UNITED STATES PATENT AND TRADEMARK OFFICE

APPLICATION NO.	FILING DATE	FIRST NAMED INVENTOR	ATTORNEY DOCKET NO.	CONFIRMATION NO.
10/707,860	01/19/2004	Ren-Ting Hou	WISP0043USA	1859

Office Action Summary	Application No.	Applicant(s)	
	10/707,860	HOU ET AL.	
	Examiner	Art Unit	
	Khanh Dang	2111

DETAILED ACTION

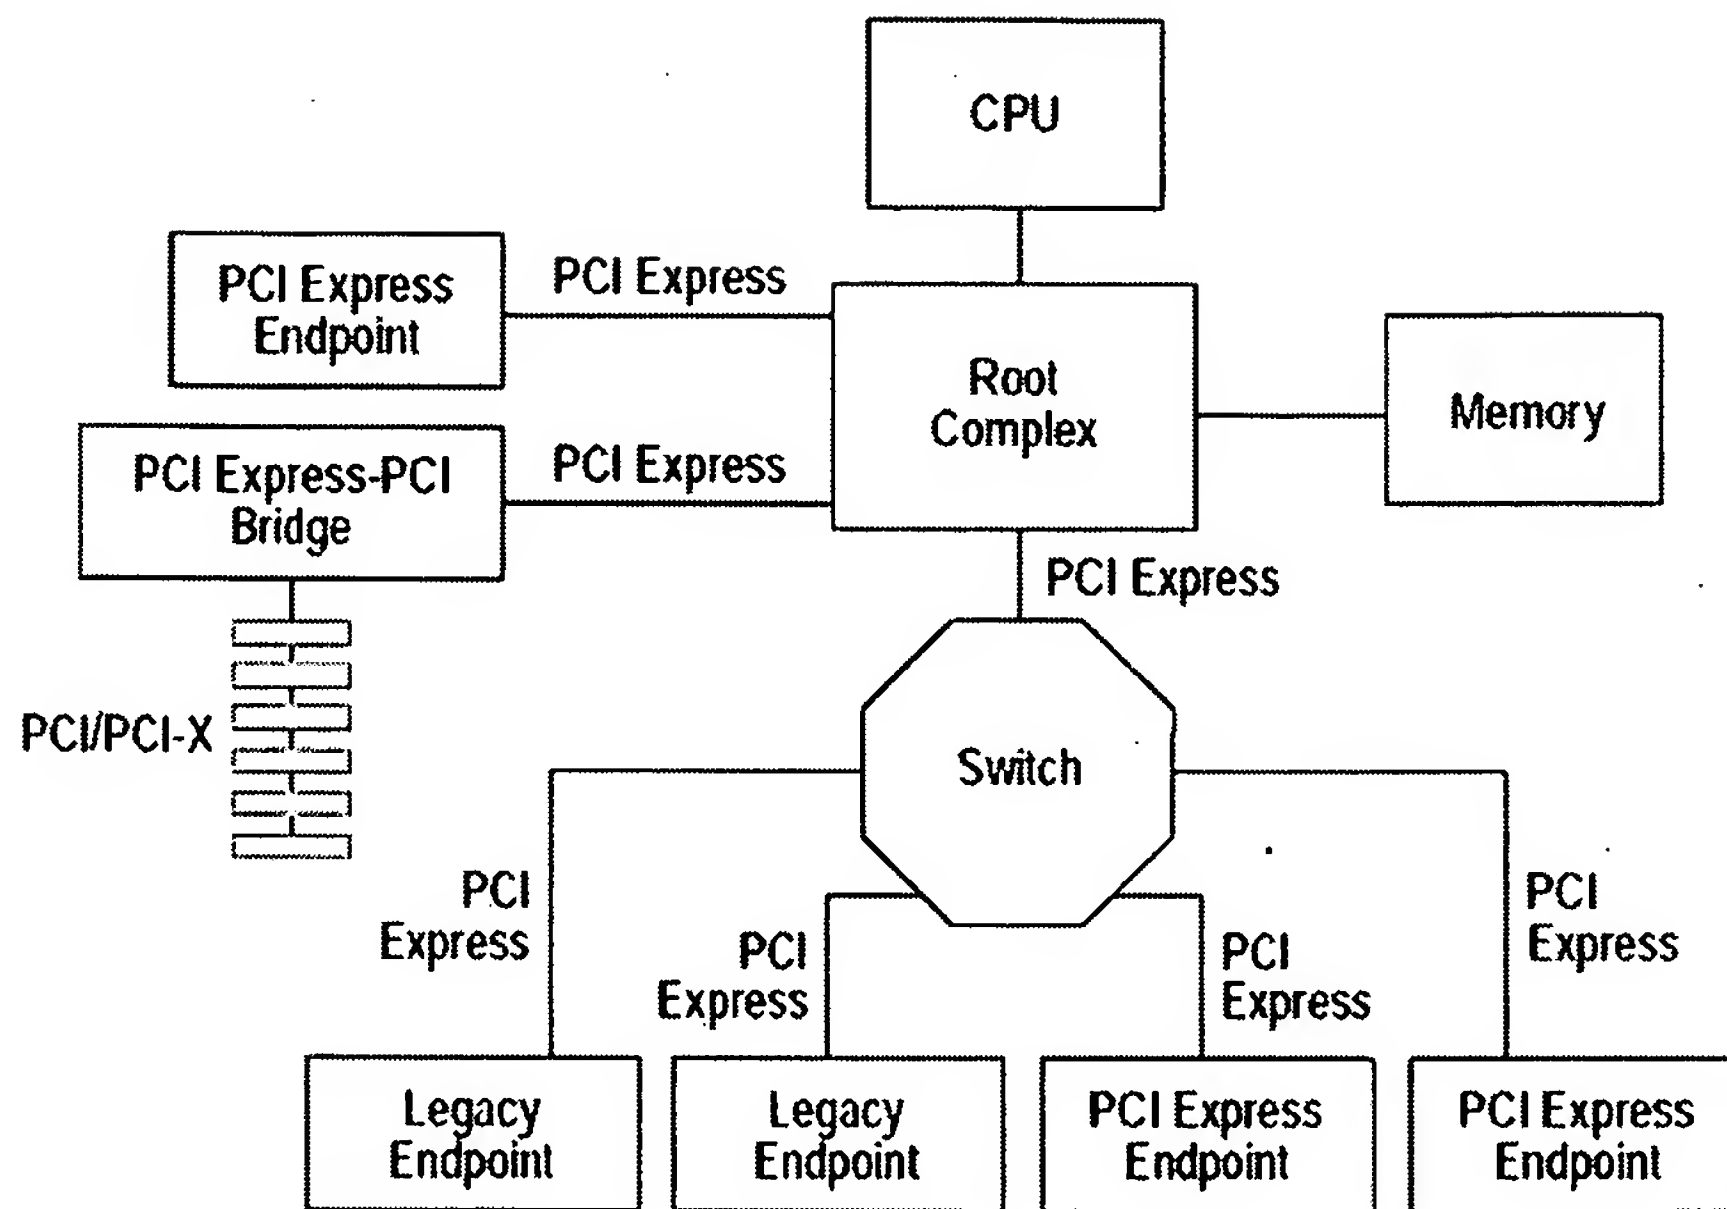
With regard to claim 5, PCI Express discloses an extendable computer system comprising: a motherboard for maintaining the functionality of the computer system (it is clearly inherent that computer system based on PCI Express must be laid out on a motherboard or main board. As shown below at Figs. 1-2, on page 31, of the PCI Express, the PCI Express based computer system including a CPU, buses, and peripheral components must be placed on a motherboard or main board)

, the motherboard comprising: a system chipset for supporting a specification of a first interface (the Root Complex Port Chip Set in PCI Express manages the PCI Express fabric, and supports PCI Express interface); at least one first standard communication interface slot electrically connected to the system chipset for electrically connecting at least one peripheral device to the computer system (it is clear from the PCI Express, Figure 1-2 above that each PCI Express Endpoint comprises a PCI Express slot for a plug-in PCI Express card or peripheral device); and a first extending port electrically connected to the system chipset for extending functionality of the motherboard (it is clear that the PCI Express bus of the motherboard connecting the Root Complex chipset to the PCI Express-PCI/PCI-X bridge has a first port for providing connection to second port of PCI Express-PCI/PCI-X bridge for the motherboard to extend its functionality to the PCI/PCI-X legacy peripherals); and an extended board capable of electrically connecting to the motherboard for extending the functionality of the

computer system (PCI Express-PCI/PCI-X bridge as shown above in Fig. 1-2, i.e. the Intel 41210 PCI Express-PCI/X bridge, cited below, is capable of electrically connecting to the motherboard for extending the functionality to the legacy PCI-X peripherals), the extended board comprising: a second extending port capable of electrically connecting to the first extending port for electrically connecting the extended board to the system chipset of the motherboard (it is clear that the PCI Express bus of the motherboard connecting the Root Complex chipset to the PCI Express-PCI/PCI-X bridge has a first port for providing connection to second port of PCI Express-PCI/PCI-X bridge for the motherboard to extend its functionality to the PCI/PCI-X legacy peripherals), wherein at least one end of the second extending port is in accordance with the specification of the first interface (it is clear from the PCI Express, Fig. 1-2, one end of the PCI Express-PCI/PCI-X bridge supports PCI Express interface); a second interface converter electrically connected to the at least one end of the second extending port for converting the first interface into a second interface (it is clear that the PCI-Express-PCI/PCI-X bridge, as its name implies, provides an interface converter connected to one end of the second port for converting the PCI Express interface into a PCI-X interface); and at least one second standard communication interface slot electrically connected to the second interface converter for electrically connecting at least one peripheral device to the computer system (it is clear from the PCI Express, Figure 1-2 above that each PCI-X comprises a PCI-X slot for a plug-in PCI-X card or peripheral device), wherein the at least one second standard communication interface slot is in accordance with the specification of the second interface (the PCI-X slot for a plug-in PCI card must be in full

With regard to claim 10, as discussed above, the first interface is a PCI Express interface, the second interface is a PCI-X interface, and the second interface converter is a PCI Express/PCI-X interface converter.

With regard to claim 11, it is clear from the PCI Express, Fig. 1-2, that the Root Complex is in the North Bridge chipset connected the CPU. Note that the Root Complex chipset can be in either the North Bridge chipset or a South Bridge chipset (see PCI Express: Interconnect of the Future from Anandtech, cited below).

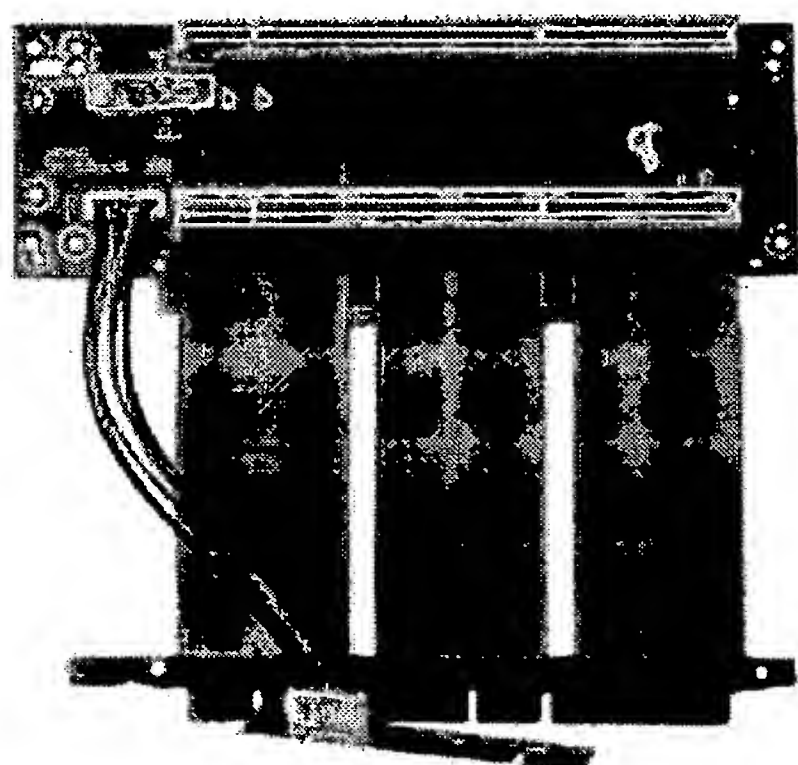
However, the use of a matched gold finger consisting of a gold finger slot and gold finger for providing a connection between the motherboard and the extended board, particular in riser card/board, is old and well-known as evidenced from Garreau (6,769,035) or Rackmountmart.com. Garreau discloses the use of gold finger 30 (Fig. 1A) mated with gold finger slot (Fig. 2) for providing connection between a motherboard and an extended board. Rackmontmart.com also discloses the use of PCI Express gold finger mated with gold finger slot on a motherboard (motherboard slot-6 (PCI-e X16), as shown below:

Note that with the matched gold finger consisting of a gold finger and a gold finger slot provided by either Garreau or Rackmountmart, extended board and the motherboard are aligned in the same plane through the connection of the extending ports, particularly with the use of a riser card/board.

It would have been obvious to one of ordinary skill in the art at the time the invention was made to provide the motherboard and extended board of PCI Express with a matched gold finger consisting of a gold finger and a gold finger slot is old and well-known, as evidenced from Garreau (6,769,035) or Rackmountmart.com; and
